# PROPOSED DON SAHONG HYDROPOWER PROJECT- MEKONG RIVER

Technical Review for Prior Consultation Project  
Review Report:  
Assessment of Impacts on Sediment Transport and  
Geomorphology of the Lower Mekong River

December 5, 2014

Project No.141-5902

**Figure 10 Predicted cumulative mass of deposited sediment in DSHPP head pond (SMEC 2014c) with trend line added by reviewer.**

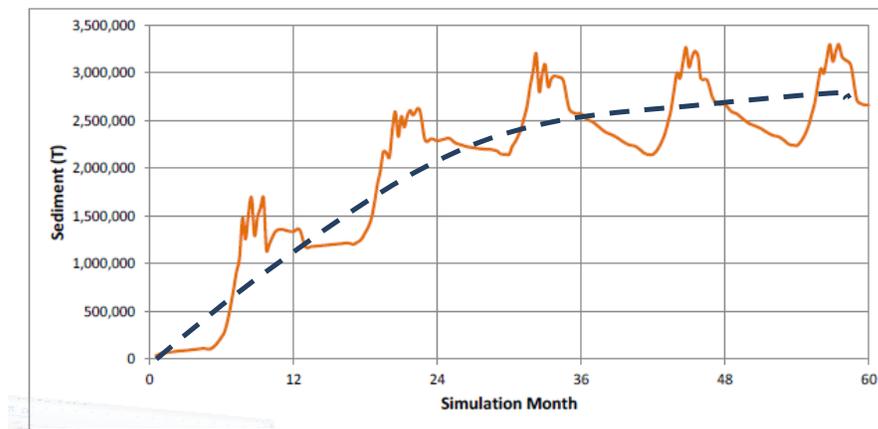
Using the results provided by SMEC (2014c) it can also be argued that the modeling results indicate a continued increase in sedimentation of the headpond, though at a slower rate after the second year of operation. The reviewer added a trend line on Figure 10 which implies that a new geomorphic equilibrium has not been reached by year 3, but that sediment deposition is expected to continue in the headpond of DSHPP. It implies that the reservoir may eventually completely fill with sediment.

This is less of a concern for the developer than what it is for the Government of Laos. If the headpond of DSHPP is substantially filled with sediment at the end of the concession period it may compromise the ability of the Government to generate hydropower unless substantial maintenance cost is incurred.

In the worst case it is estimated that the reservoir could completely fill with deposited sediment in about 34 years, assuming that the total bedload of 700,000t/yr will remain in the reservoir every year and that the density of the deposited sediment is 1,590kg/m<sup>3</sup> (SMEC 2014c). The reviewer concedes that this is a worst case scenario; thereby requesting the Consultant to extend the computer simulation of the headpond sedimentation for a much longer period than five years. It is deemed in the best interest of the Government of Laos to gain more certainty about reservoir sedimentation and its potential implications on hydropower production in the long term.

It is recommended that the Consultant executes sediment transport simulations through the headpond using a much longer duration, possibly on the order of about 35 years. The results of such simulations will reduce the uncertainty regarding the impacts of sedimentation, the volume of deposited sediment, and how soon a new geomorphologic equilibrium will transpire in the headpond.
